Subject: Workplan Addendum to **05/10/07** Workplan to Conduct Site  
Remediation Activities 1075 40<sup>th</sup> Street, Oakland, CA 94608  
ACDEH Site No. RO000186

Subject: Workplan Addendum  
1075 40<sup>th</sup> Street, Oakland, CA 94608  
ACDEH Site No. RO000186

Gribi Associates is pleased to submit this workplan addendum on behalf of Fidelity Roof Company for the underground storage tank (UST) site located at 1070 40<sup>th</sup> Street in Oakland, California (see Figure 1 and Figure 2). This letter provides additional explanation and information requested in the letter from Alameda County Department of Environmental Health (ACDEH) dated May 23, 2007.

DESIGNED BY:	CHECKED BY:	<b>SOIL TPH-G RESULTS</b>	DATE: 06/06/2007	FIGURE: <b>3</b>
DRAWN BY: JG	SCALE:			
PROJECT NO: 330-01-01		1075 40TH STREET OAKLAND, CALIFORNIA

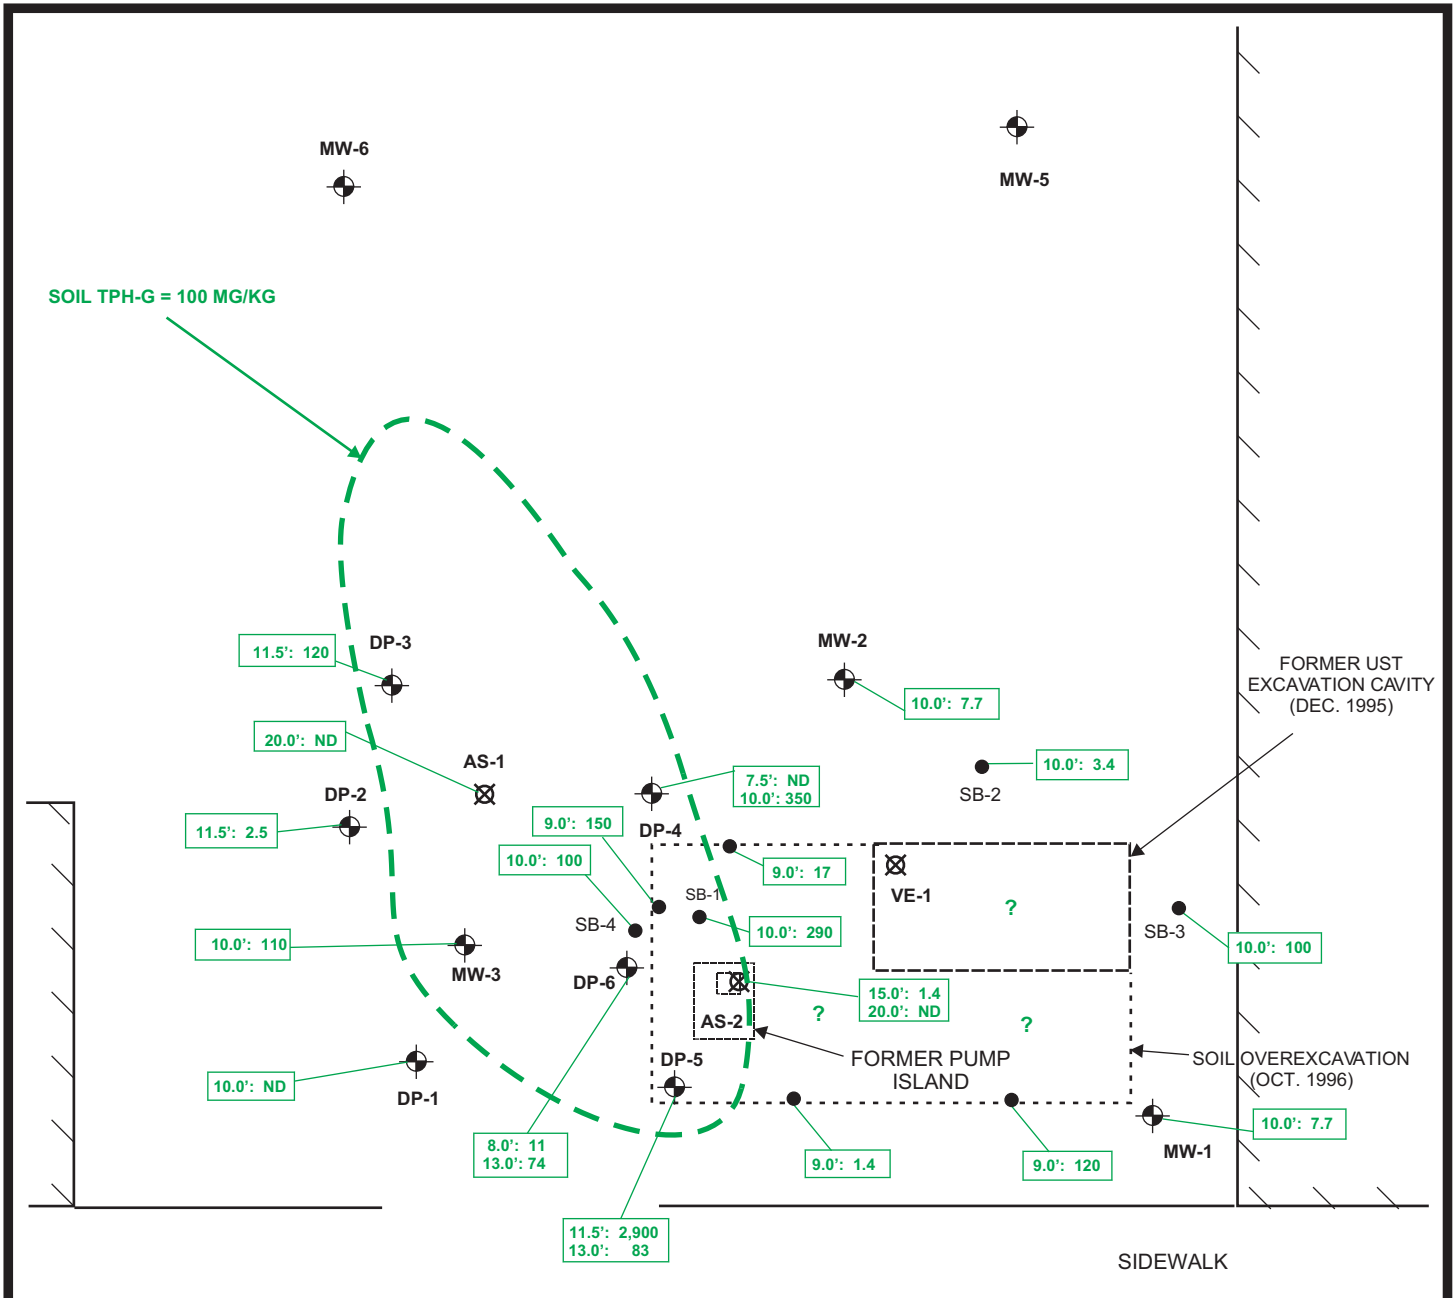
Soil TPH-G and benzene concentrations for all identified soil sample analyses except for those collected during UST removal activities (for which we do not have copies of reports) are shown on Figures 3 and 4, respectively. We have not included MTBE soil results, since almost all MTBE soil analysis were run using USEPA Method 8015M, which often produces false positive results.

- While the previous consultant, AEI, did not generally provide vertical hydrocarbon delineation in soil borings and excavations, there are a few more recent borings (DP-4, DP-5, DP-6, and AS-2) where multiple soil samples were analyzed. These analysis, and particularly those from DP-4 and DP-5, seem to confirm a hydrocarbon smear zone from 8 feet to 12 feet in depth, whereby soil samples below 12 feet in depth are not hydrocarbon-impacted, and soil samples that are not in the immediate UST source area and are shallower than about 8 feet in depth are also not hydrocarbon-impacted.

- Given this typical hydrocarbon smear zone in soils away from the UST source areas, soil samples collected at about 10 feet in depth in these non-source area borings are clearly representative of hydrocarbon soil impacts in the hydrocarbon smear zone. Thus, while soil hydrocarbon impacts are not defined vertically in the former excavation areas, they are reasonably well defined in downgradient unexcavated areas.

DESIGNED BY:	CHECKED BY:	<b>PROPOSED BORING LOCATIONS</b>	DATE: 06/06/2007	FIGURE: <b>5</b>
DRAWN BY: JG	SCALE:			
PROJECT NO: 330-01-01

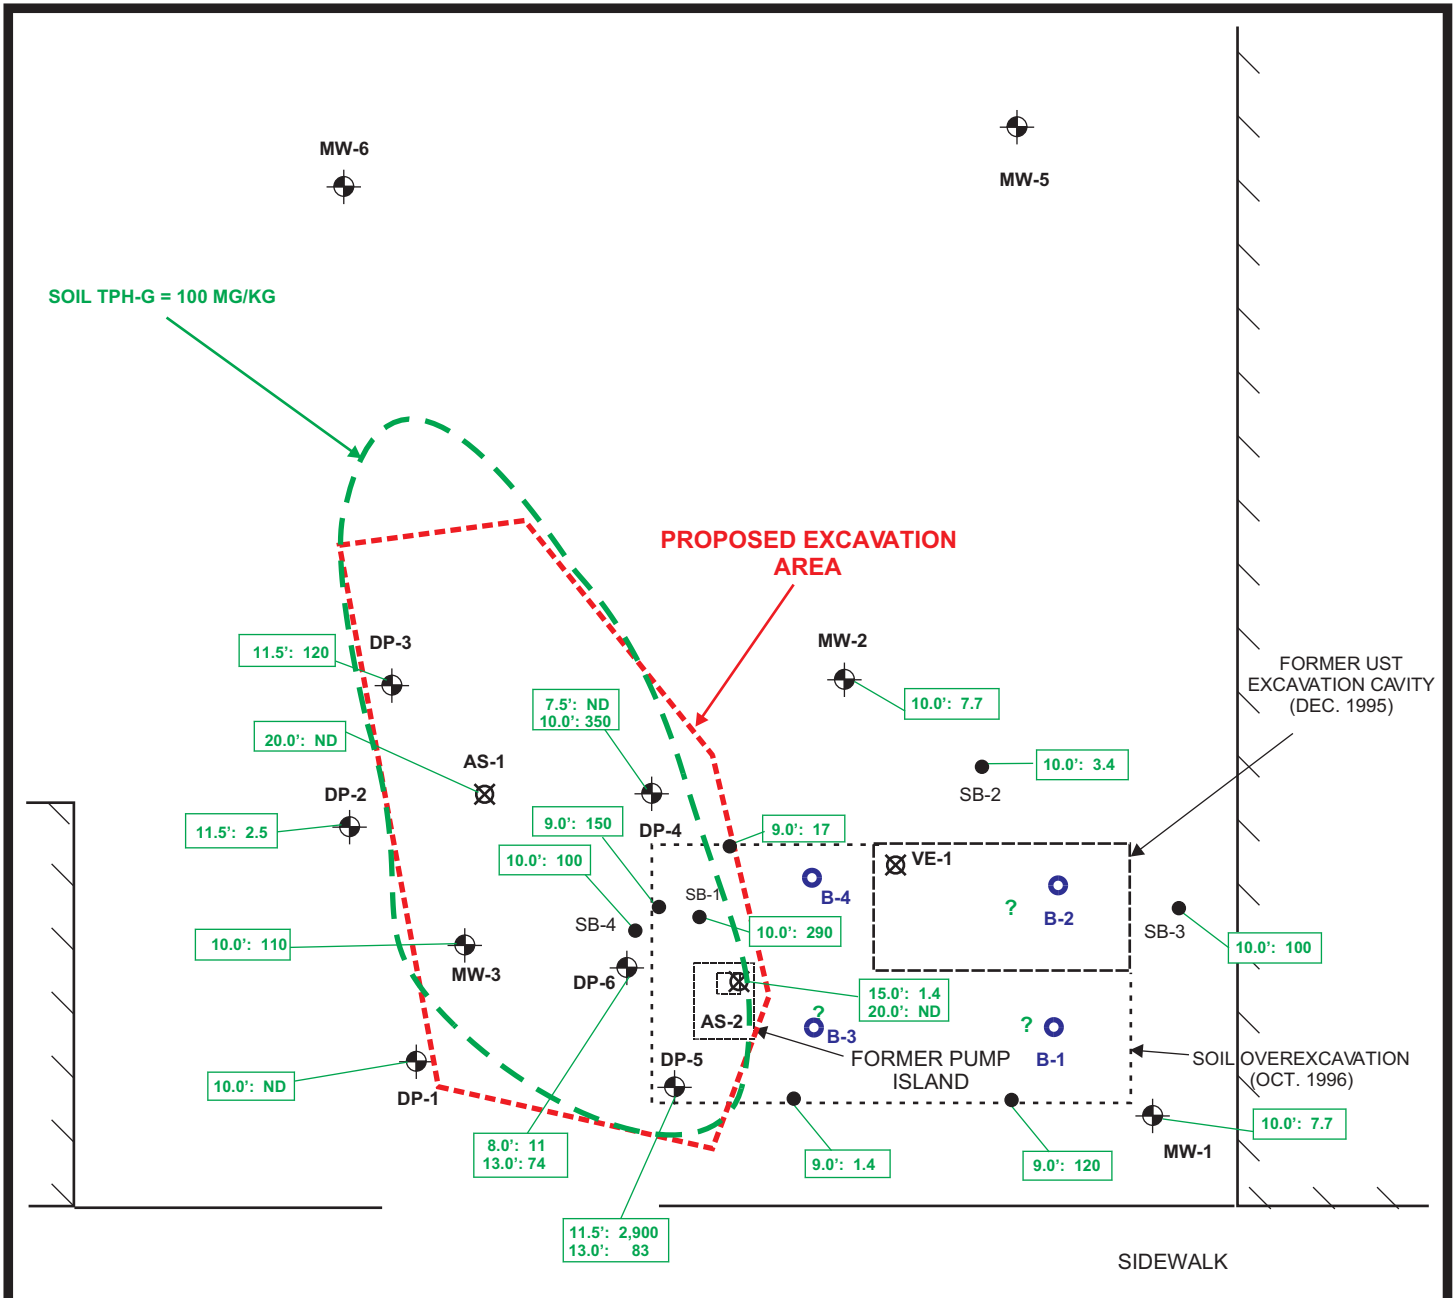
In order provide additional site characterization, Figure 5 shows proposed locations for 4 soil borings. The 4 borings will be drilled to at least 25 feet in depth. Soil samples will be collected at five-foot intervals and at obvious lithologic changes or evidence of hydrocarbon impacts. Two grab groundwater samples will be collected from each boring, the first at first encountered groundwater and the second by hydropunching below 20 feet in depth. Soil and groundwater sampling activities will be conducted in accordance with standard sampling guidelines and protocols. Soil and groundwater samples will be analyzed for TPH-G/BTEX and Oxygenates.

DESIGNED BY:	CHECKED BY:	<b>GROUNDWATER MTBE RESULTS &amp; PROPOSED OZONE INJECTION PLAN</b>  1075 40TH STREET OAKLAND, CALIFORNIA	DATE: 06/06/2007	FIGURE: <b>6</b>	
DRAWN BY: JG	SCALE:				
PROJECT NO: 330-01-01

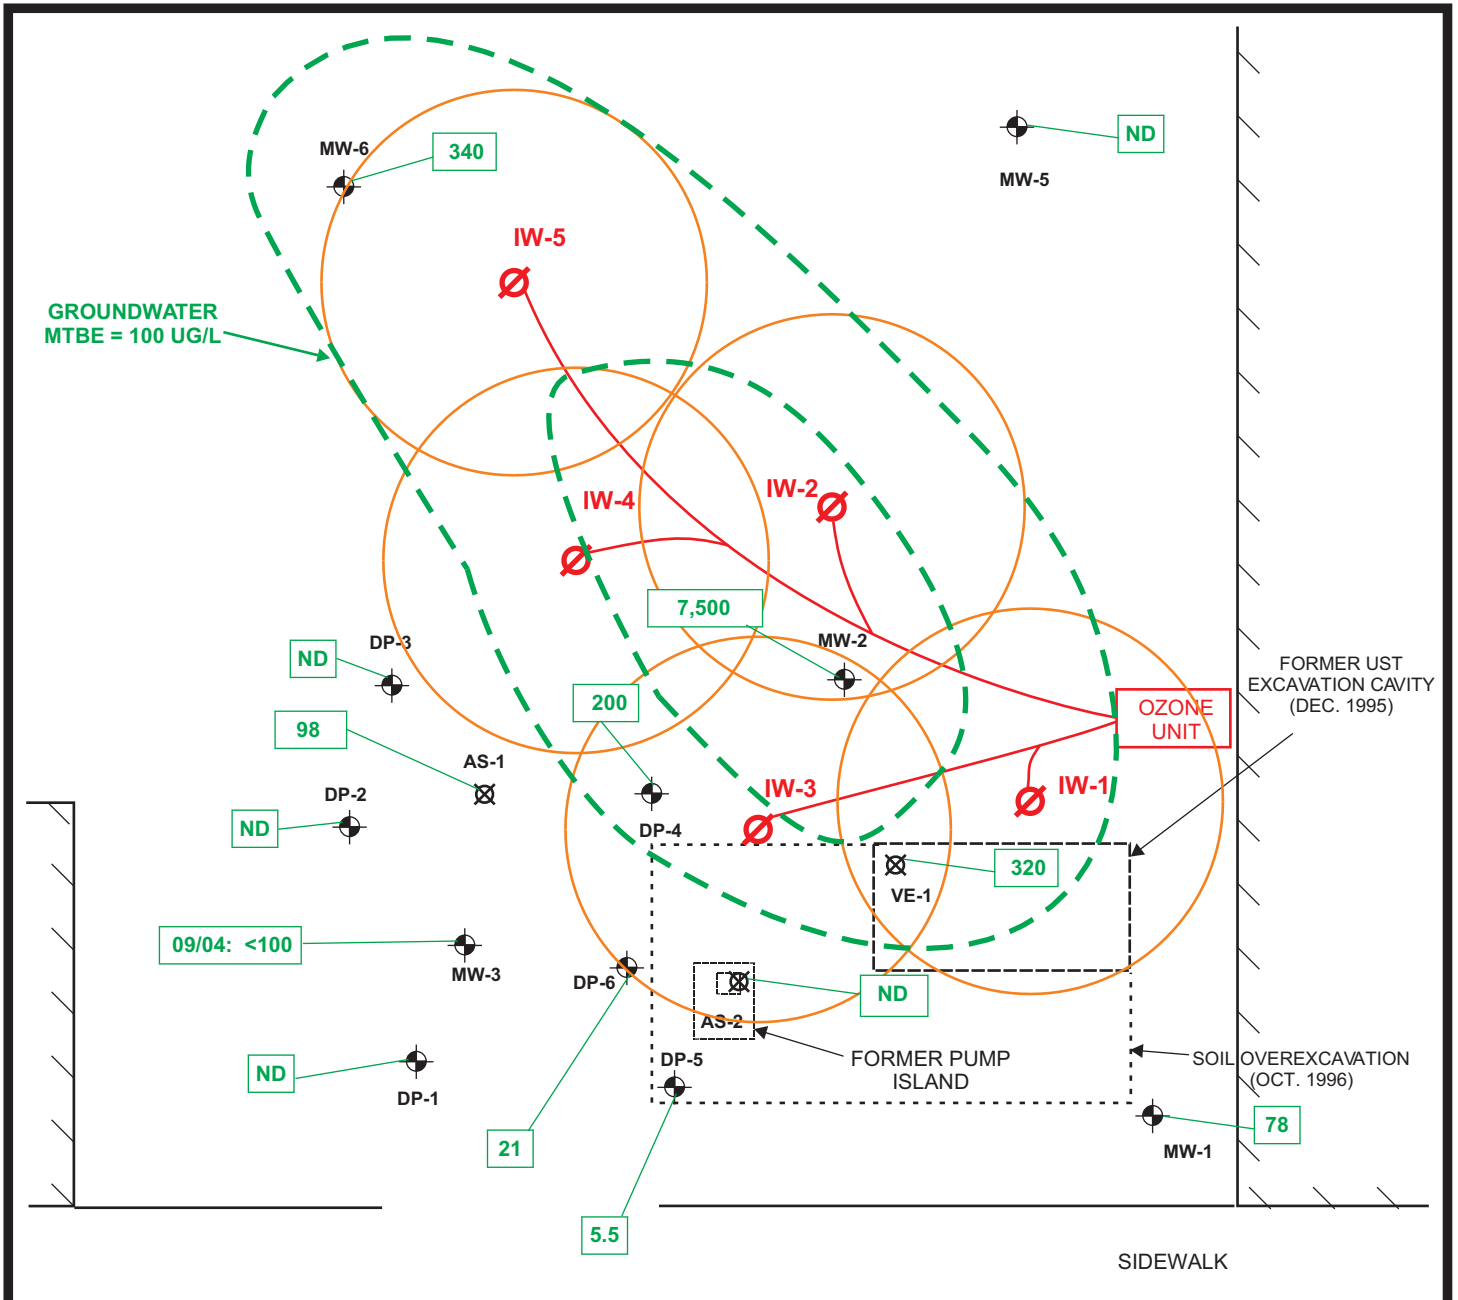
The following explanations correspond to specific questions contained in the May 23, 2007 letter from ACDEH. Location of the proposed injection wells are shown on Figure 6.

### *How was the (ozone) injection depth selected?*

*How will you verify the radius of influence of the ozone?*

In choosing ozone injection depths, one tries to place the injection point deep enough below the water table to create an effective radius of influence, while not going so deep that ozone either can't reach the water table or takes too long to filter upward to the water table, where groundwater hydrocarbon impacts are greatest. Some information from vendors has suggested a radius of influence of approximately 1.5 to 2.0 times the injection depth below the water table. While we have found this approximation to be, in almost every case, true, we have also found that it is important, in choosing injection depths, to review site boring logs and to try to place the injection points in relatively high-permeability soils. This allows ozone to be relatively easily injected and to be broadcast farther laterally away from the injection point before moving upward.

For the project site, after determining that we would need to place the injection points below 20 feet in depth (i.e. ten feet below the water table), we noted the presence of an apparently persistent sand in deeper well boring logs AS-1 and AS-2, and determined that placing the injection point in this sand interval would be advantageous.

Obviously, the injection depth can, and often will, be altered slightly in the field based on boring lithology. In this case, after reaching a depth of 20 feet, we will sample continuously to 25 feet in depth using a split spoon sampler, and will place the injection point in the first high permeability zone below 20 feet.

The two indicators which will be used to monitor ozone injection radius of influence are: (1) Field monitoring of dissolved oxygen in surrounding wells MW-1, MW-2, MW-5, MW-6, VE-1, DP-1, and DP-2; and (2) MTBE and hydrocarbon concentrations in surrounding wells. We have found that dissolved oxygen is a very useful field indicator of ozone influence. Given the variable distances of surrounding monitoring wells from injection wells, these field monitoring results will provide a useful indication of effective radius of influence. Ultimately, decreases in MTBE and hydrocarbon concentrations in groundwater in surrounding wells will provide a clear indication of ozone radius of influence.
